**Subject: Wetlands & Stormwater Review #4 for
Sterling Road 40B Project, Lancaster**

I am submitting a fourth peer review of the proposed Sterling Road 40B project, based on the May 7, 2019, letter to the Board by CEI. The emphasis of my current letter is on the negative impact to the now-confirmed vernal pool and to the downstream coldwater fishery, if the development is approved.

Figure 1. Vernal pool is shown in red, detention basins in light purple and wetland line in green.

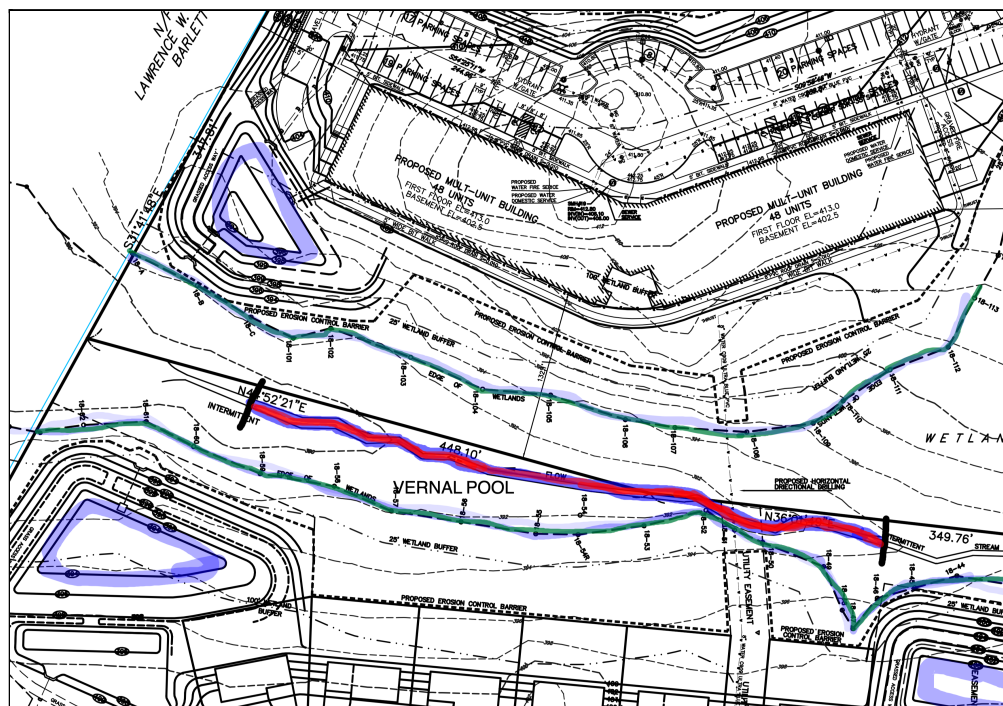
Referring to Figure 1 above, I note that the VP lies directly beside the discharge points for three proposed detention basins. This creates two problems. Outflow from the basins during storm events may destroy the viability of the VP, as (1) volume will increase post-development, and (2) effluent from the stormwater basins will contain pollutants, including higher pH, salts, hydrocarbons and herbicides/pesticides. **These combined disruptions will impair, if not destroy, the habitat required for VPs.**¹

➡ **The MassDEP Wetland Protection Act requires a 100-foot buffer around certified VPs, and provides VPs additional protection as Outstanding Resource Waters (ORWs). The ORW designation prohibits placement of detention basins within 50-feet of a VP. Yet the proposed project places two of the three basins within this 50-foot no-build zone, and all the basins within the 100-foot buffer. The design must be revised.**²
